In response refer to RFP No. 24MCO634 Addendum 2 and Response to Questions August 8, 2024

ADDENDUM NO: 002

PROJECT NAME: Midland County Sheriff's Office Utilities

PROJECT NO.: 41563.23

**Sewer Line A
Plan and Profile
Sta 0+00 To
Sta 6+00**

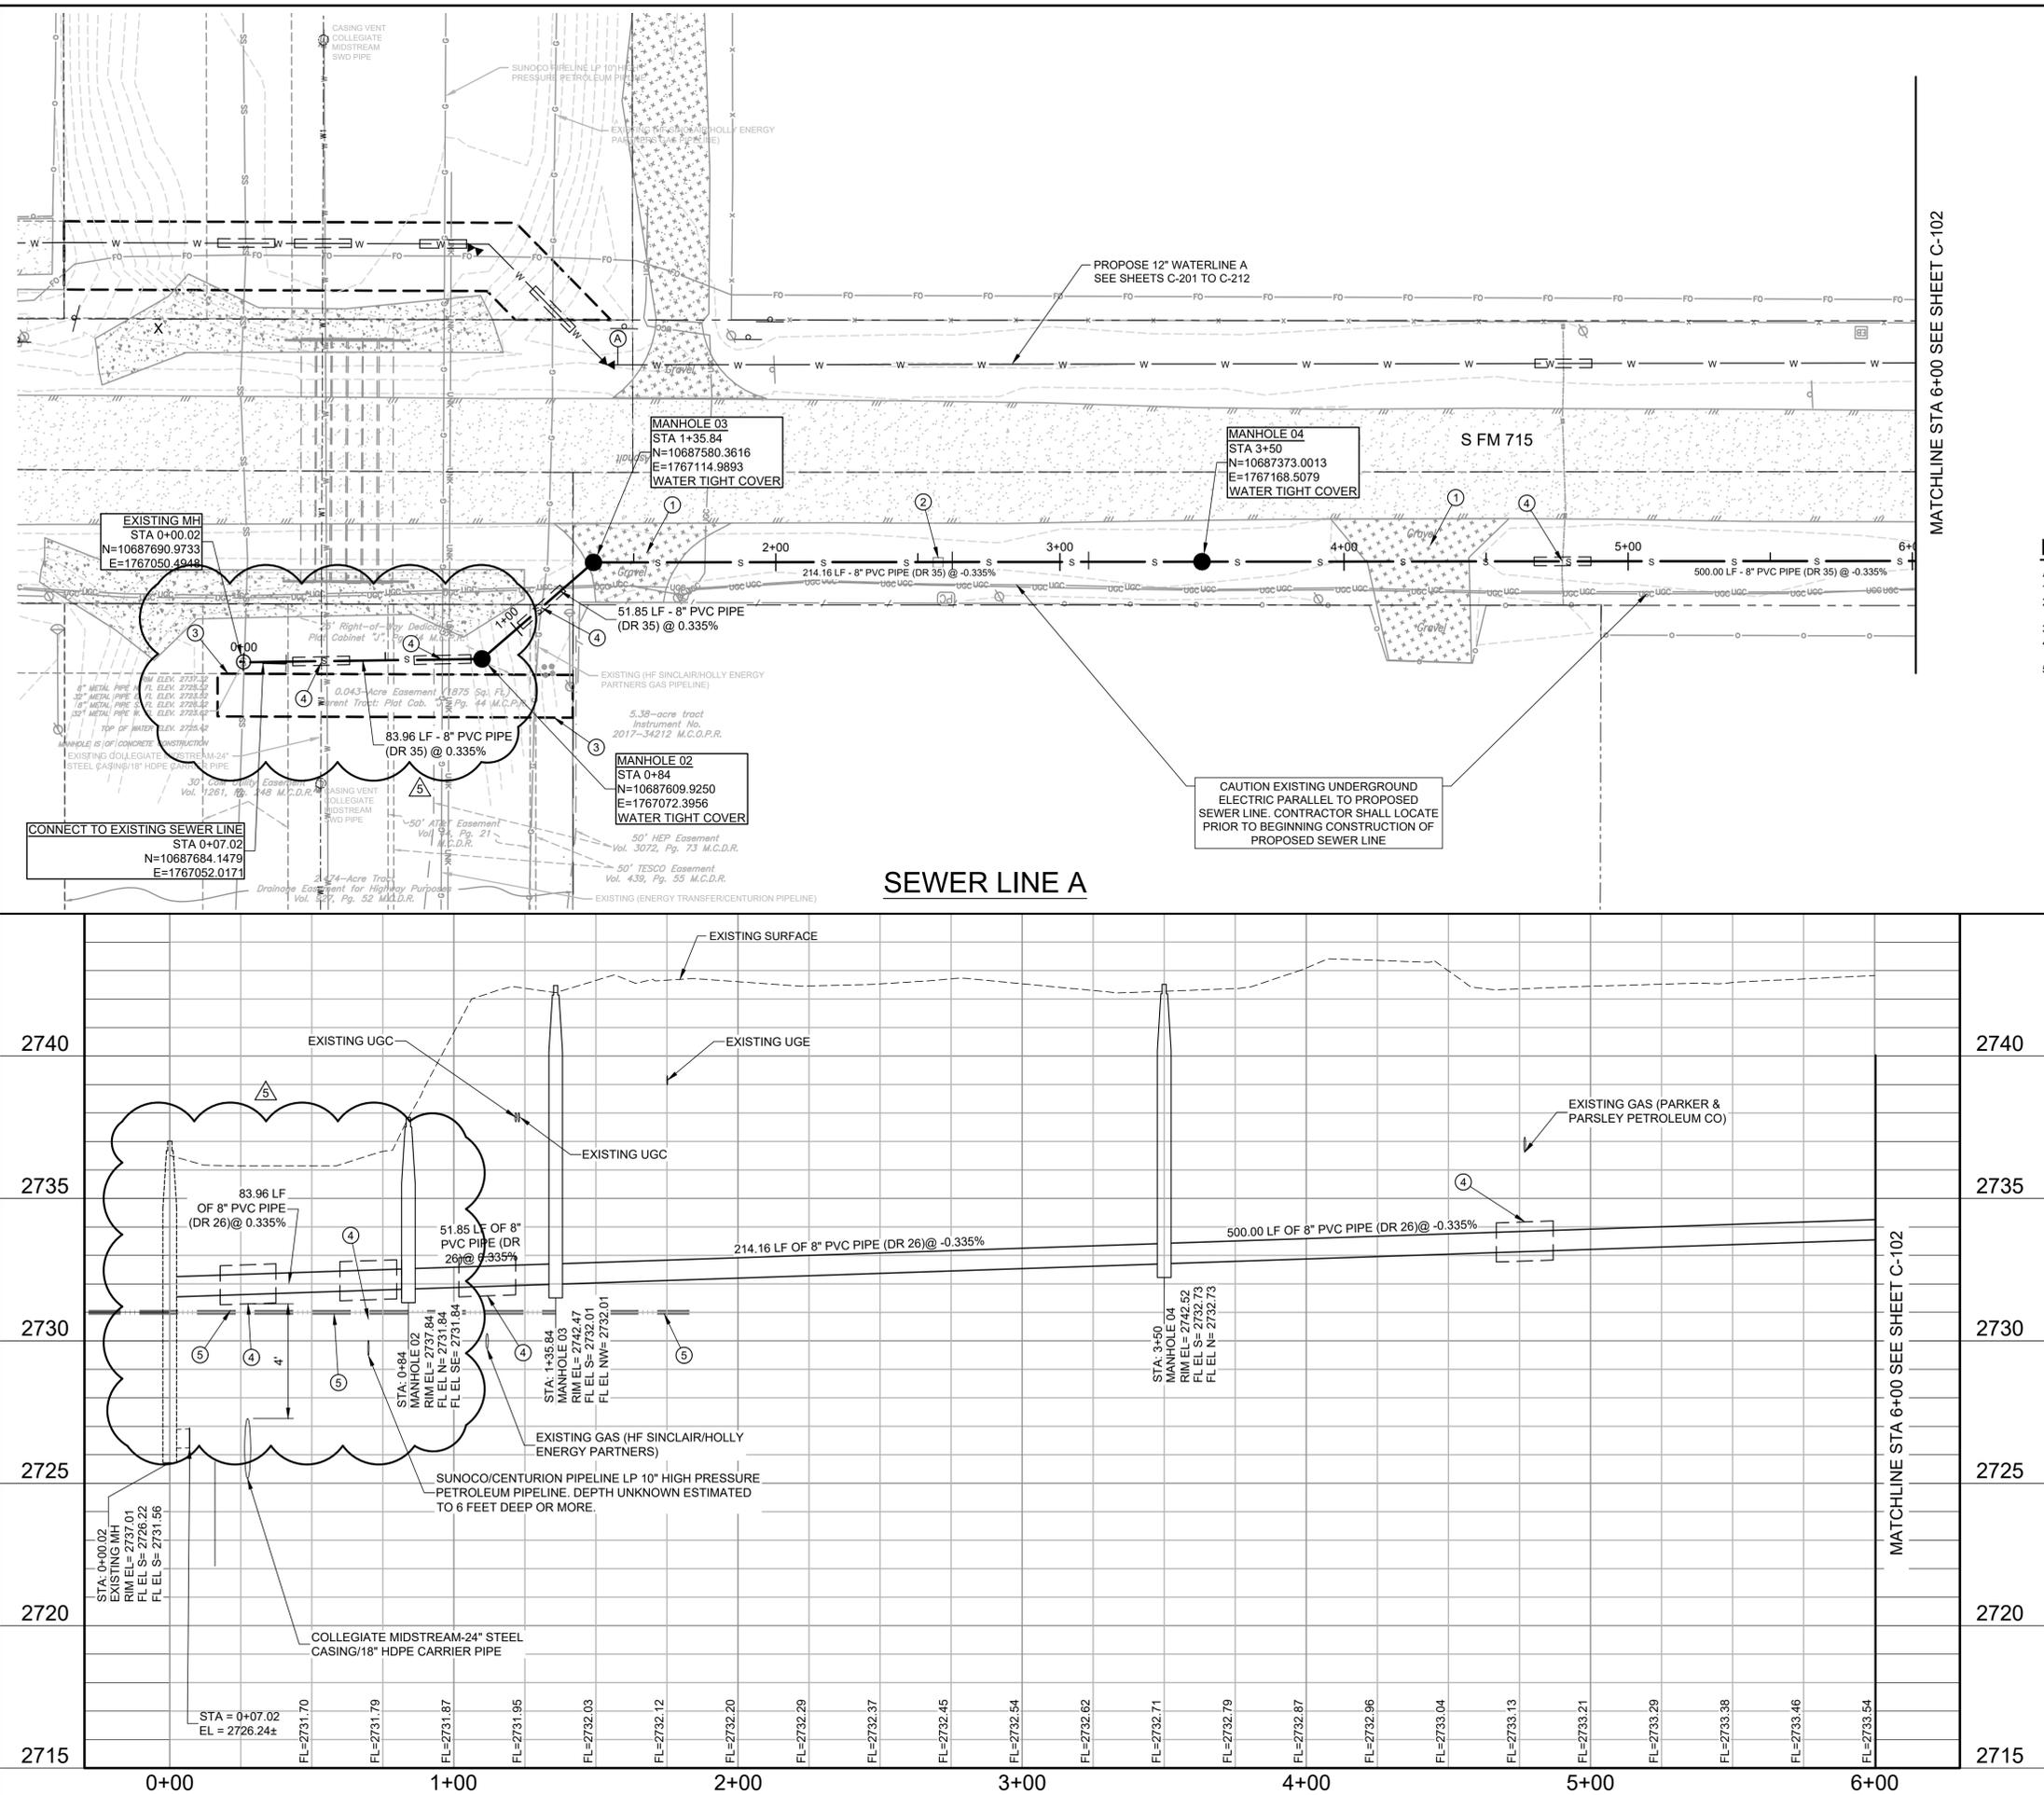
1. Changed design as reflected in C101 to tie directly to the existing City manhole. Carl was concerned that it was a concrete manhole initially but it is fiberglass. This way we can stay slightly above the groundwater at the connection area. Reduced time for Dewatering based on this adjustment.
2. G002 was changed to show the Staging sites for the contractor.
3. Changes to the bid form:
 - a. Reduced dewatering days
 - b. Reduced manholes as we eliminated one at the connection point.
 - c. Added note to Gravel Pavement replacement item. There is a lot of gravel replacement associated with the County areas I think they should be able to remove the existing gravel topping and reuse to reduce the cost of this item.
 - d. Removed the \$ figure shown on 'completion time' item.

1. SHEET G-002 – PROJECT LOCATION AND CONTROLS
 - a. REMOVE and REPLACE Sheet G-002 in its entirety as attached to this Addendum.
2. SHEET C-101 – SEWER LINE A PLAN AND PROFILE STA 0+00 TO STA 6+00
 - a. REMOVE and REPLACE Sheet C-101 in its entirety as attached to this Addendum.
